RECORD DRAWING

TITLE: CESAR E. CHAVEZ COMMUNITY CENTER
GRADING PLAN

| City Project No. | Zone Map No. | Sheet |
|---|---|---|
| 4876.92 | L–19–Z | C1.1 |

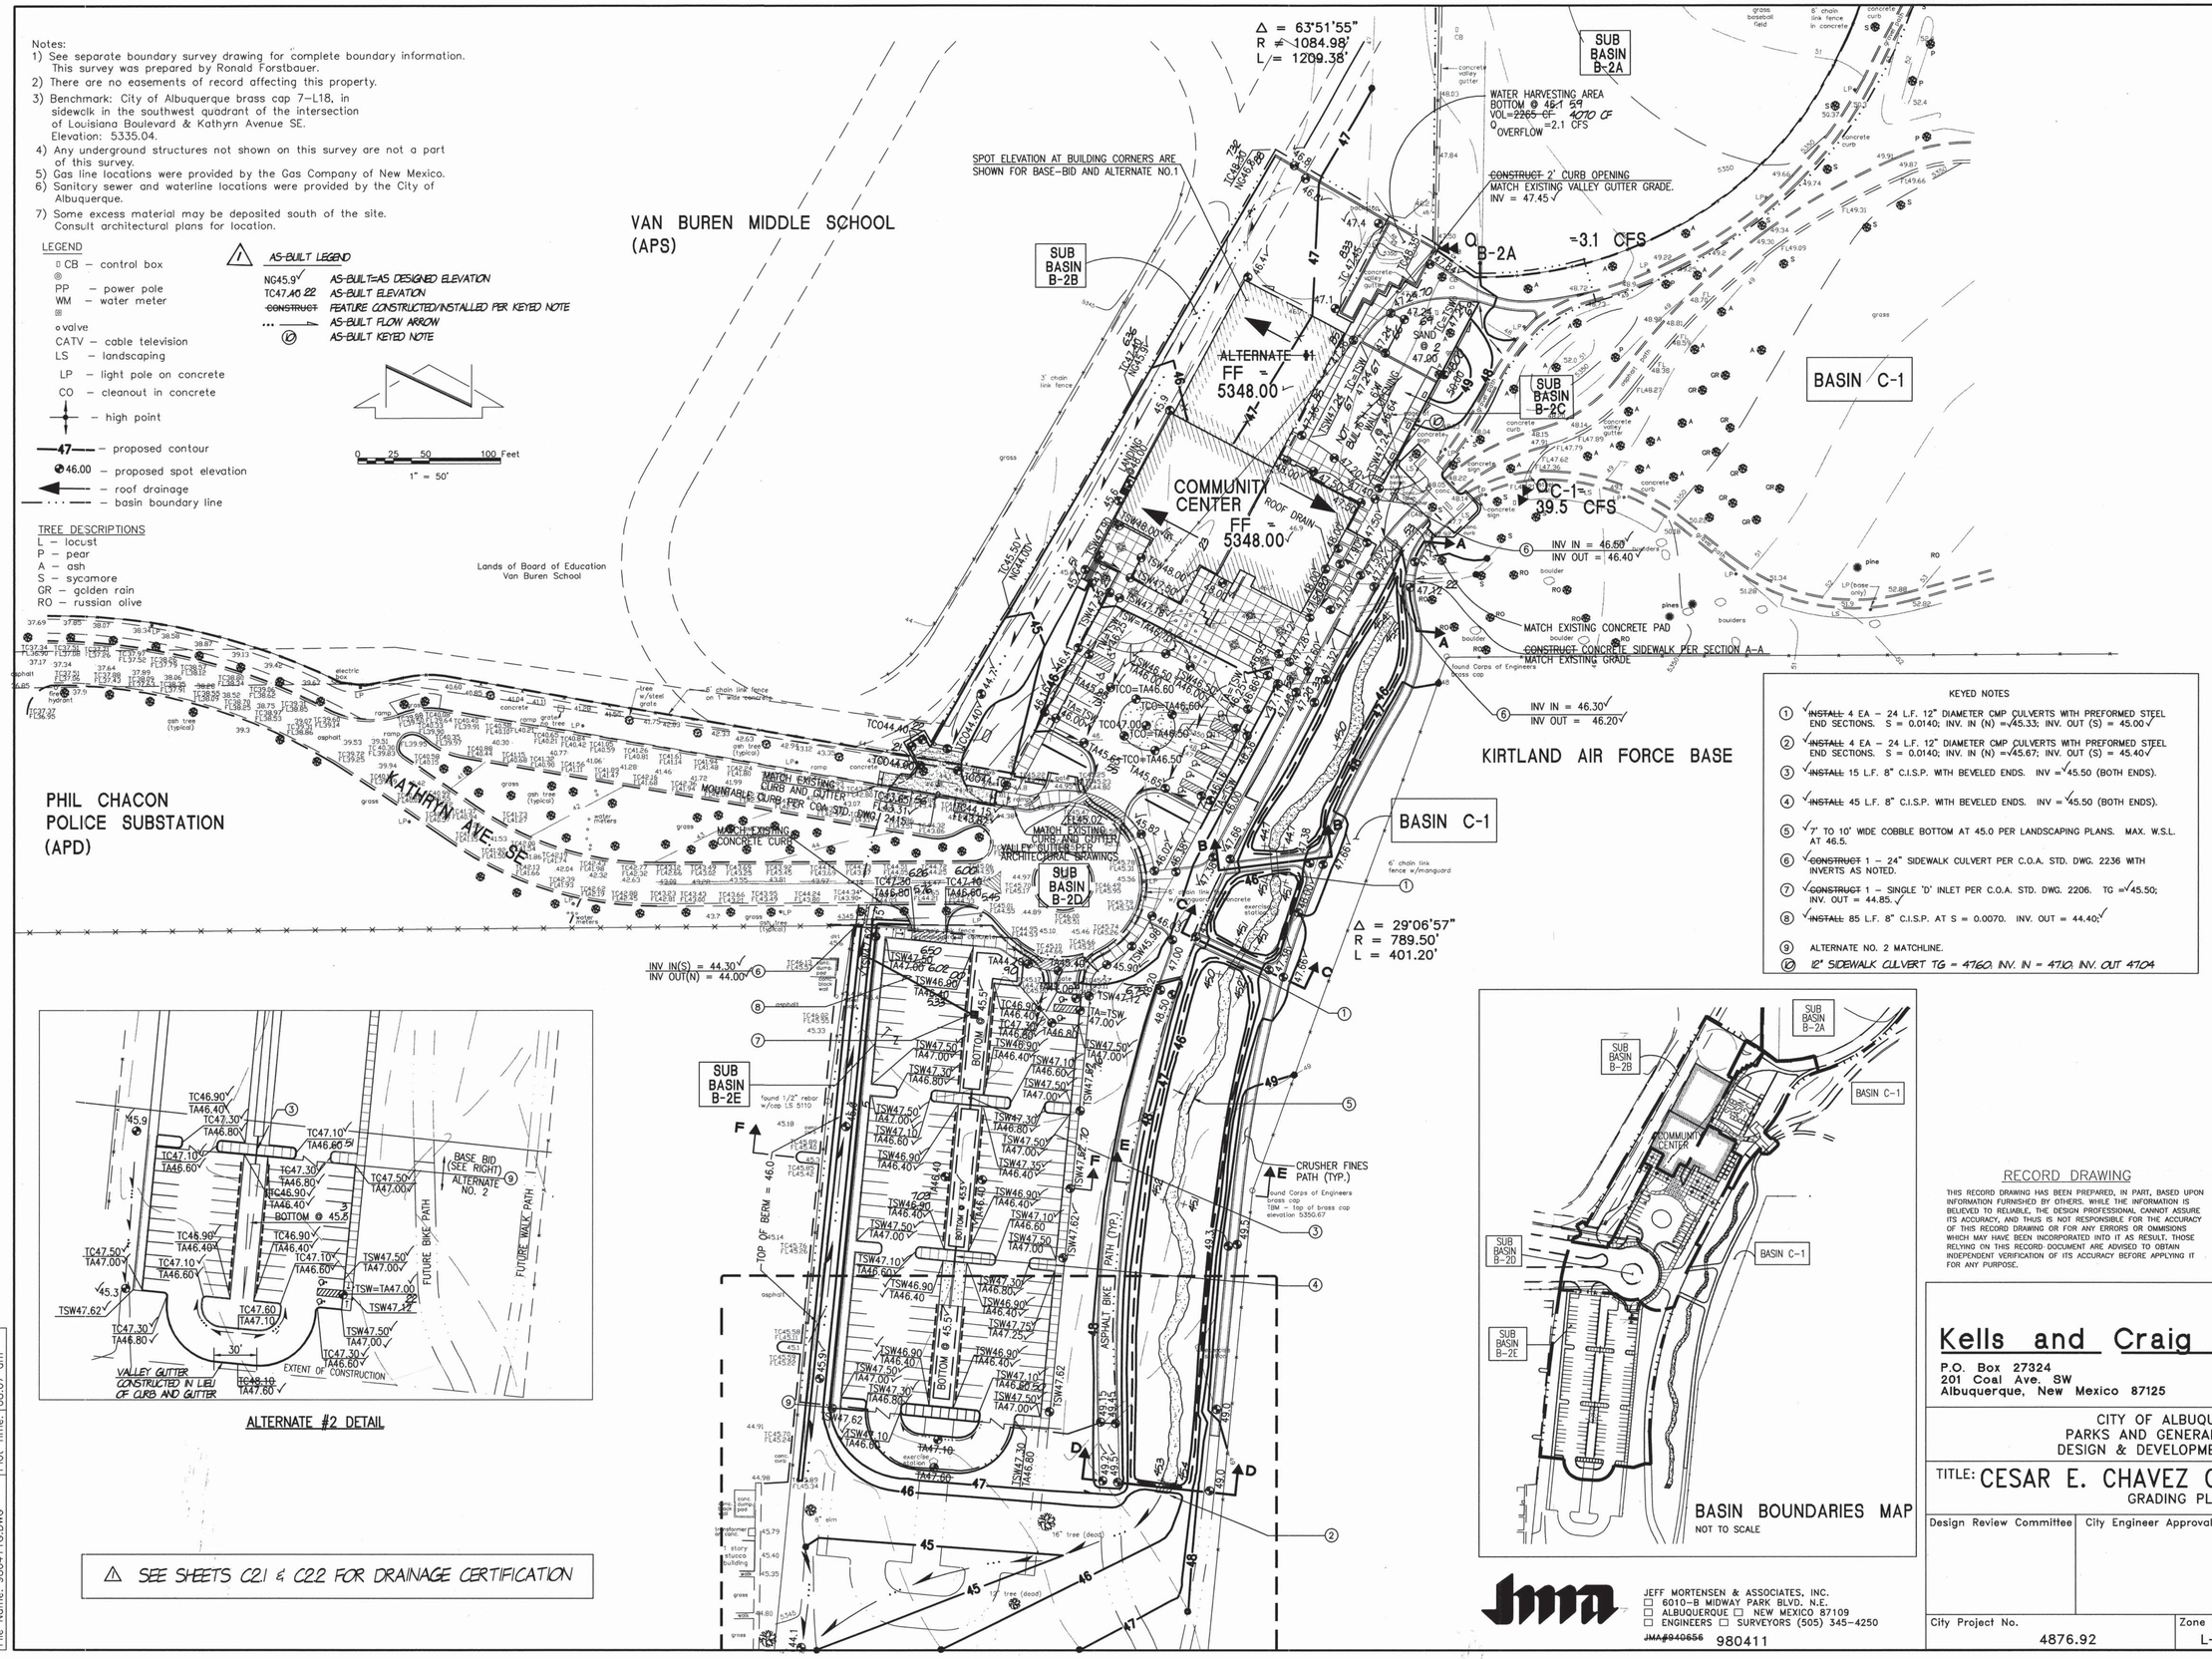
AS-BUILT LEGEND
- NG45.9 – AS-BUILT=AS DESIGNED ELEVATION
- TC47.10 22 – AS-BUILT ELEVATION
- ~~CONSTRUCT~~ – FEATURE CONSTRUCTED/INSTALLED PER KEYED NOTE
- AS-BUILT FLOW ARROW
- AS-BUILT KEYED NOTE

1. ~~INSTALL~~ 4 EA – 24 L.F. 12" DIAMETER CMP CULVERTS WITH PREFORMED STEEL END SECTIONS. S = 0.0140; INV. IN (N) =45.33; INV. OUT (S) = 45.00
2. ~~INSTALL~~ 4 EA – 24 L.F. 12" DIAMETER CMP CULVERTS WITH PREFORMED STEEL END SECTIONS. S = 0.0140; INV. IN (N) =45.67; INV. OUT (S) = 45.40
3. ~~INSTALL~~ 15 L.F. 8" C.I.S.P. WITH BEVELED ENDS. INV =45.50 (BOTH ENDS).
4. ~~INSTALL~~ 45 L.F. 8" C.I.S.P. WITH BEVELED ENDS. INV =45.50 (BOTH ENDS).
5. 7' TO 10' WIDE COBBLE BOTTOM AT 45.0 PER LANDSCAPING PLANS. MAX. W.S.L. AT 46.5.
6. ~~CONSTRUCT~~ 1 – 24" SIDEWALK CULVERT PER C.O.A. STD. DWG. 2236 WITH INVERTS AS NOTED.
7. ~~CONSTRUCT~~ 1 – SINGLE 'D' INLET PER C.O.A. STD. DWG. 2206. TG =45.50; INV. OUT = 44.85.
8. ~~INSTALL~~ 85 L.F. 8" C.I.S.P. AT S = 0.0070. INV. OUT = 44.40;
9. ALTERNATE NO. 2 MATCHLINE.
10. 12" SIDEWALK CULVERT TG = 47.60. INV. IN = 47.10. INV. OUT 47.04
